**STATE OF NORTH DAKOTA
PUBLIC SERVICE COMMISSION**

**Basin Electric Power Cooperative
345 kV Trans. Line - Mercer,Dunn,McKenzie,Williams
Siting Application**

Case No. PU-11-696

**NOTICE OF FILING AND NOTICE OF OPPORTUNITY FOR HEARING
August 4, 2014**

Basin Electric Power Cooperative
 Antelope Valley Station to Nenet
 345-kV Transmission Project
 Route Change Map

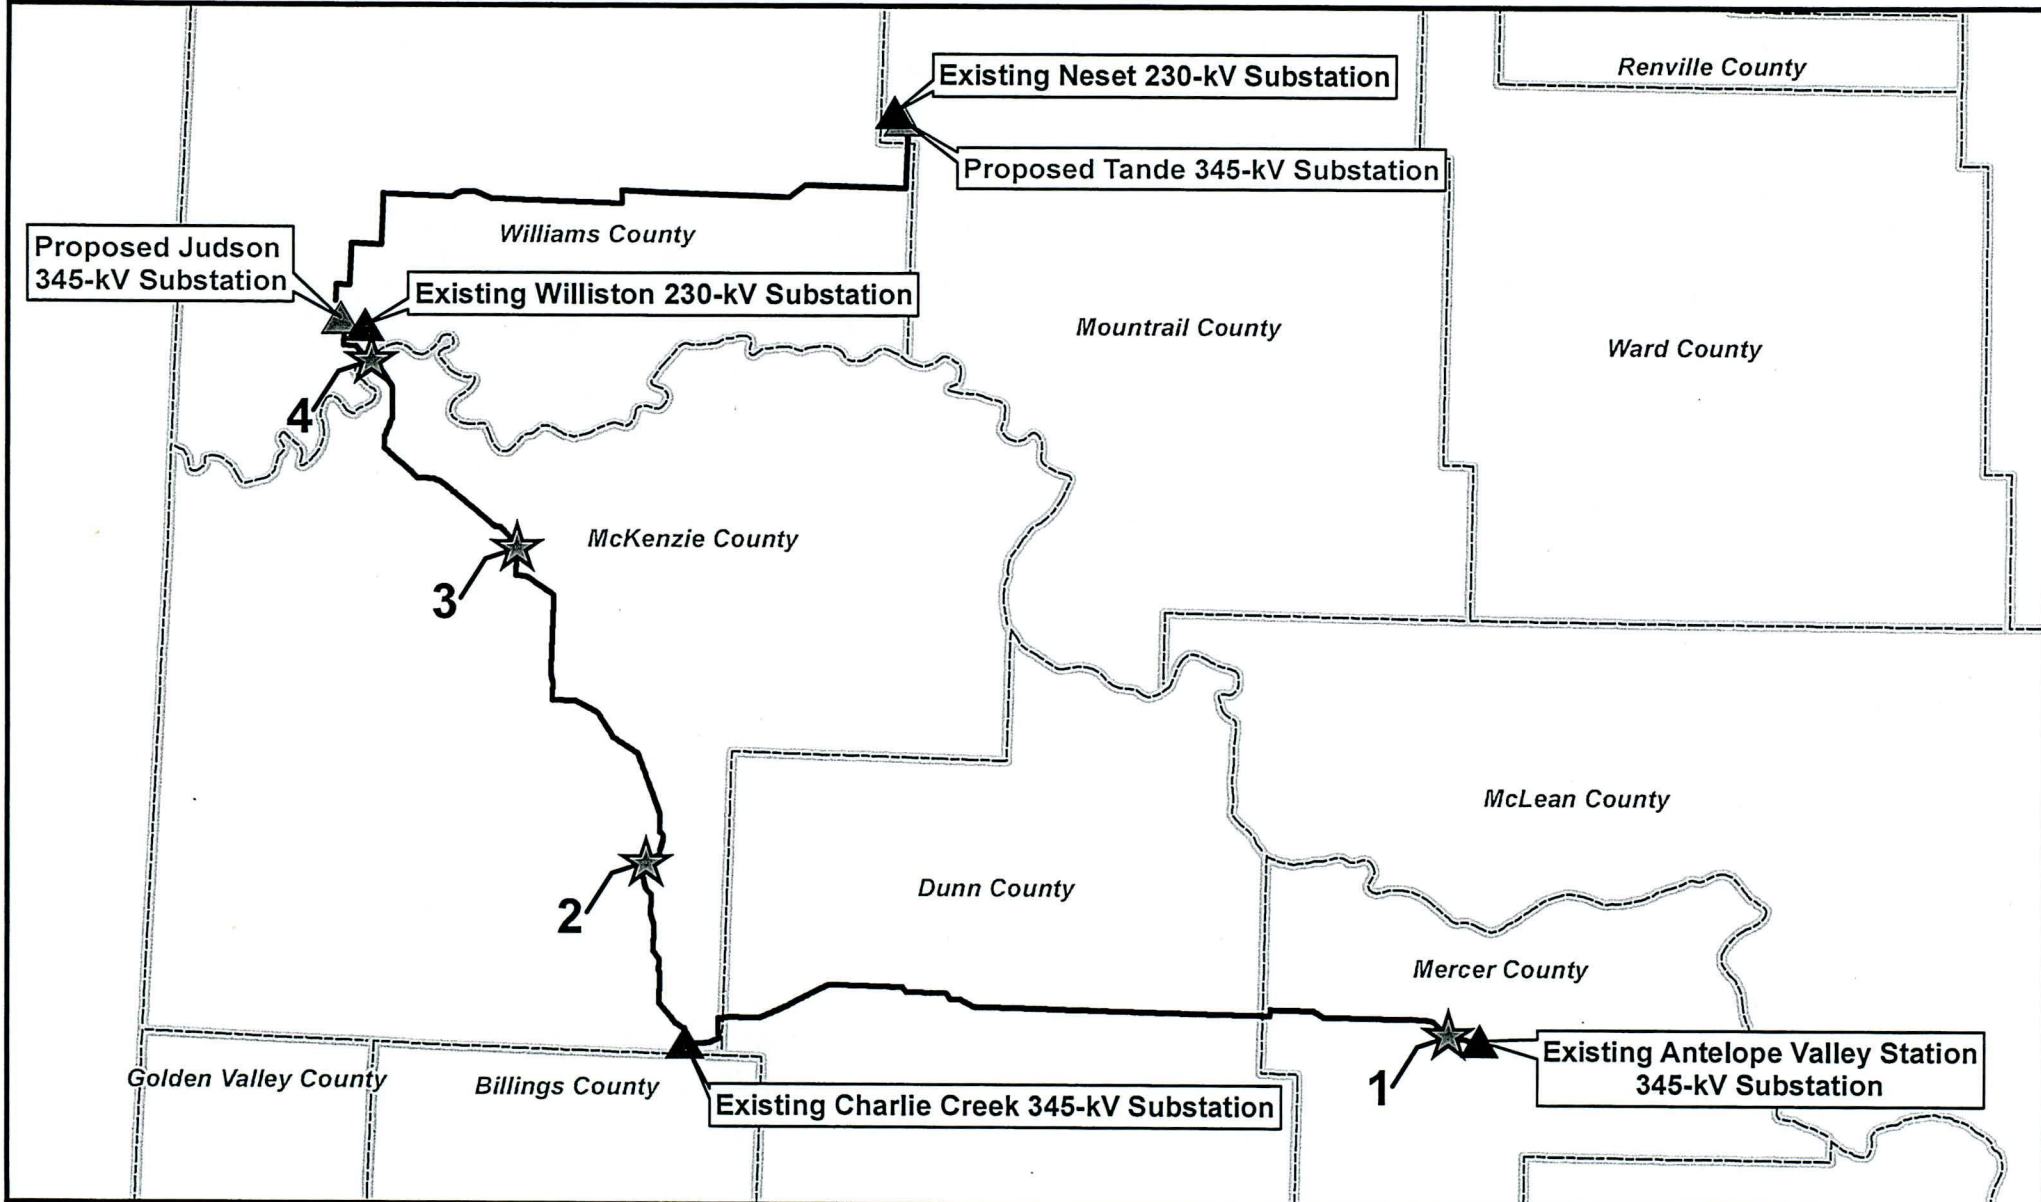
On July 23, 2014 Basin Electric filed an amendment to its applications for corridor and route requesting modifications at four locations along the approved corridor and route as indicated on the attached map and described below:

1. T145N, R88W, Sections 14-16 and 21-23 in Mercer County: Several transmission lines entering the Antelope Valley Station (AVS) substation are proposed to be reconfigured and rerouted. An existing AVS to Charlie Creek 345 kV line and an existing AVS to Broadland 345/500 kV line would be relocated and double circuited for approximately two miles along the previously approved AVS to Neset 345 kV corridor and route in the S1/2 of sections 14-16. That two mile segment of the new AVS to Neset 345 kV corridor and route would be shifted south to the existing AVS to Broadland right-of-way through the N1/2 of sections 21-23 before proceeding north through section 16 where it is double circuited for approximately 3/4 mile with the rerouted existing AVS to Charlie Creek 345 kV line. Also, the entrance into the AVS substation for an existing AVS to Leland Olds Station 345 kV line would be shifted slightly south.

2. T147N, R99W, Sections 13 and 24 in McKenzie County: Realignment of approximately 2,100 feet of the approved corridor and route, shifting further east of Highway 85 a maximum of 300 feet to accommodate US Forest Service request.

3. T151N, R100W, Sections 5,8,9,10,1,15,16,22,26 and 27 in McKenzie County: Realignment of approximately three miles of the approved corridor and route, shifting approximately 1/2 mile west from the previous alignment.

4. T153N, R101W, Section 6 in McKenzie County: A slight westward adjustment of approximately 3/4 mile of the approved corridor and route on the south side of the Missouri River crossing to accommodate ND Game & Fish request.
